CASE NO. 792-V-14 REACTIVATED
SUPPLEMENTAL MEMORANDUM
March 22, 2016

Request: **Authorize the following Variance from the Champaign County Zoning Ordinance in the I-1 Light Industry Zoning District on the subject property described below:**

Subject Property: **Lot 4 of the Stahly Subdivision in the Southeast Quarter of Section 8 of Champaign Township and commonly known as the former LEX building located at 310 Tiffany Court, Champaign.**

A revised site plan has been received from Andrew Fell Architecture. See attached. This memorandum reviews new evidence to be added to the Summary of Evidence.

A1

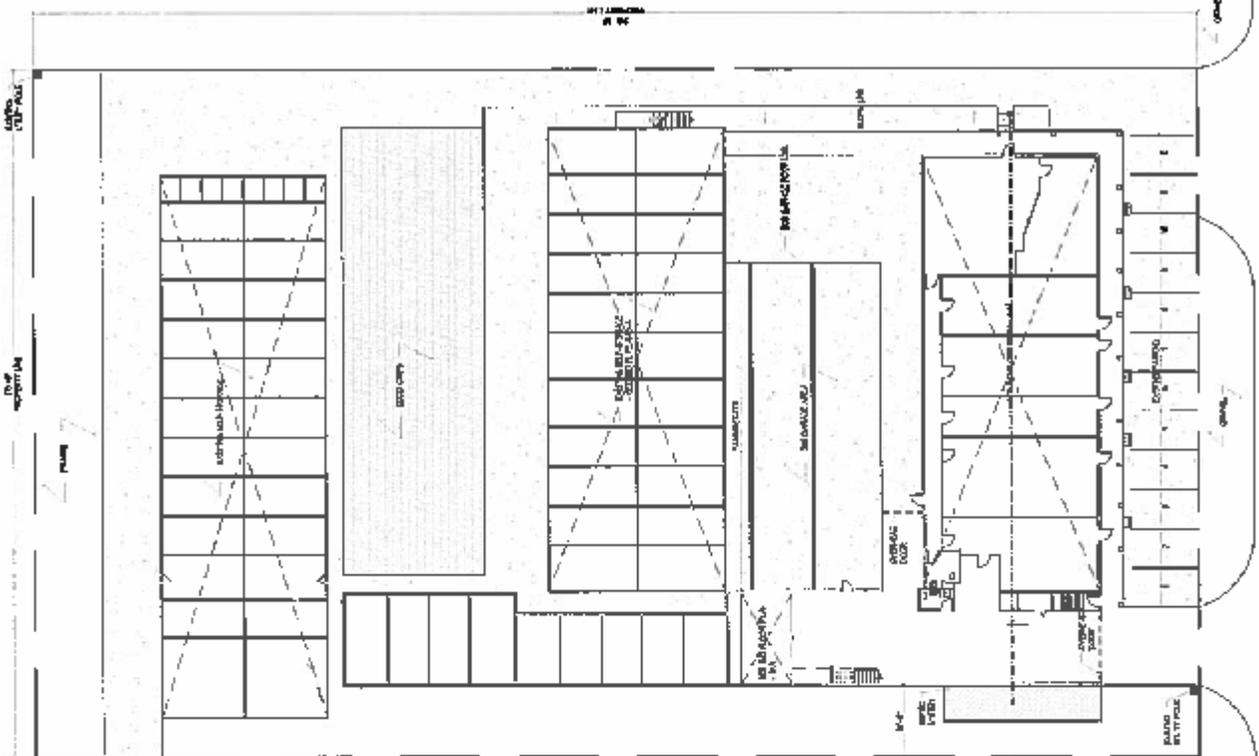
- J. A revised site plan titled “310 Tiffany Court Addition” was received from Andrew Fell Architecture on 3/21/16 that indicated the following:
- a. The building area on the subject property is not a single building as was required by Zoning Use Permit #166-96-01 on 6/17/96 and had been shown on all other plans received to date. The plan received on 3/21/16 indicates that the eastern portion of the building area is actually a separate building and is not connected to the remainder of the building area. The eastern building is all self-storage warehouse space and does not constitute a second principal building on the property.

- b. The number of existing self-storage warehouse units is much greater than was previously understood due mainly to unauthorized second floor areas and therefore the minimum required number of parking spaces is much greater than previously estimated:

- (a) The south end of the eastern building is divided into eight small self-storage units rather than two units and **therefore requires an additional two parking spaces.**

- (b) Previously, the second floor self-storage area in the middle of the property was thought to contain no more than 12 self-storage units which would have required a total of 4 parking spaces. However, the plan received on 3/21/16 indicates there are 44 existing self-storage units on the second floor but one unit is proposed to be replaced by a proposed interior stair. The resulting 43 self-storage units on the second floor self-storage area in the middle of the complex **require a total of 15 additional parking spaces rather than the previous estimate of 4 parking spaces.**

- (c) The second floor in the western portion of the main building is indicated as having 14 self-storage units which **require a total of 5 additional parking spaces.**

- (d) The western portion of the main building also has a small mezzanine that appears to be less than 1,000 square feet in area and has two self-storage spaces and **requires a total of one additional parking space.**

- (e) In total, the additional self-storage units that appear on the revised plan received 3/21/16 require an additional 23 parking spaces in addition to the 58 required parking spaces that were previously identified in a letter sent by staff to the petitioner on September 17, 2015, **for a total of 81 required parking spaces.**

- (f) The number of feasible parking spaces on the subject property appears to be less than previously thought. However, even if there are at least 32 feasible parking spaces on the subject property as previously thought, when combined with the 34 parking spaces proposed to be constructed on the additional land proposed to be purchased to the north, **the resulting total number of parking spaces will only be 66 parking spaces which is 15 spaces less than required.**

- c. Both the existing and the proposed site plan are very much out of compliance with the Illinois Accessibility Code for the following reasons:
- (a) The second floor self-storage area in the middle of the complex exceeds 1,000 square feet in area and **appears to require an elevator to be compliant with the Illinois Accessibility Code.** This portion of the building area was authorized as only a single story in Zoning Use Permit #166-96-01 on 6/17/96 and the exterior stairway does not appear in aerial photographs of the property from 2002 and 2005.

- (b) The western portion of the building complex also has a second floor that is much larger than previously indicated in this public hearing and the second floor exceeds 1,000 square feet in area and **appears to require an elevator to be compliant with the Illinois Accessibility Code.** The western portion of the building area was authorized in Zoning Use Permit #351-02-03 on 1/10/03 and was authorized to be only a single story.

- (c) **The subject property has no accessible parking spaces and no accessible pathway and no accessible entrance.**
- (d) **Note that the Illinois Accessibility Code requires 4 of the 81 parking spaces to be accessible.**

- d. On the Proposed Site Plan there is no mention of replacement of the street curb that was removed without authorization from the Champaign Township Highway Commissioner.

- e. On the Proposed Site Plan there is no mention of the proposed adjacent parking to the north.
- f. Regarding the feasibility of the parking areas indicated on both the existing and proposed site plan received 3/21/16 (Note: This analysis is meant to assist or supplement the work by Andrew Fell Architecture.):

- (a) Regarding parking on the west side of the building:
- The proposed site plan indicates a clearance of 17 feet between the west property line and steps on the west side of the building. A minimum clearance of 19 feet would be required to accommodate the minimum required 9 feet width for a parking space and the generally accepted best practice minimum width of 10 feet for a one way traffic aisle. These steps were not yet constructed when the Zoning Administrator visited the property in June 2014. Removal of the steps would result in an overall clearance of 20 feet.

- The ramp on the northwest corner of the west building aligns with an existing curb cut but would conflict a traffic aisle. The ramp appears to be a feature leftover from the previous use of the property for LEX transportation and the ramp does not appear to be necessary at this time.

- **Removal of both the ramp and the steps on the west side of the building would allow up to seven parking spaces on the west side of the building.**

- (b) Regarding the courtyard space between the east building and the middle building:
- This space is 56 feet wide and the proposed site plan includes only one row of perpendicular parking with a total of 13 parking spaces and a walkway along the east building.

- However, if the east walkway were reduced to no more than 3 feet wide a row of parallel parking spaces could be include that would allow up to a total of 5 additional parking spaces with a 21 feet wide traffic aisle.

- Six of the perpendicular parking spaces could be converted and improved into three accessible parking spaces.
 - **The above revisions could provide a possible total of 15 parking spaces in this courtyard.**

(c) The site plan received on 3/7/16 indicates that the south wall of the middle portion of the building is 13 feet 9 inches from the south lot line. Note that the exterior stair encroaches into that separation.

- (f) The subject property does not appear to provide adequate access for either a garbage truck or a fire truck.
- (g) Removal of the exterior stairway on the south side of the middle building will improve access but not provide the minimum recommended width of 20 feet. No parking signs may also help reduce obstructions by other vehicles.

A2

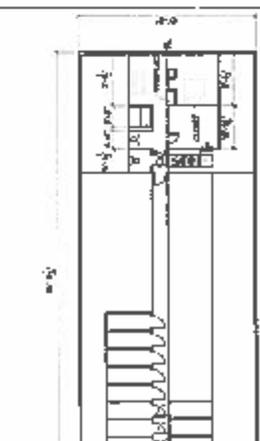
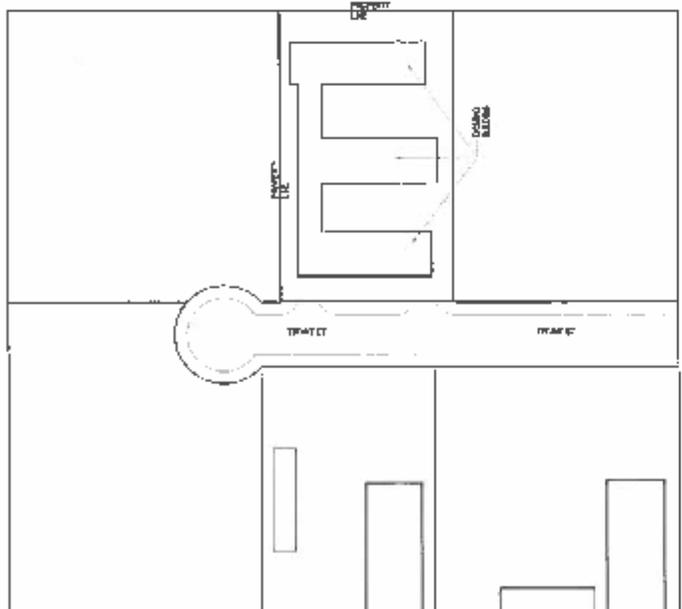
- (e) **One restroom in the western portion of the building complex is proposed to be enlarged so as to be accessible however it is not clear that only one accessible restroom is all that is required.**
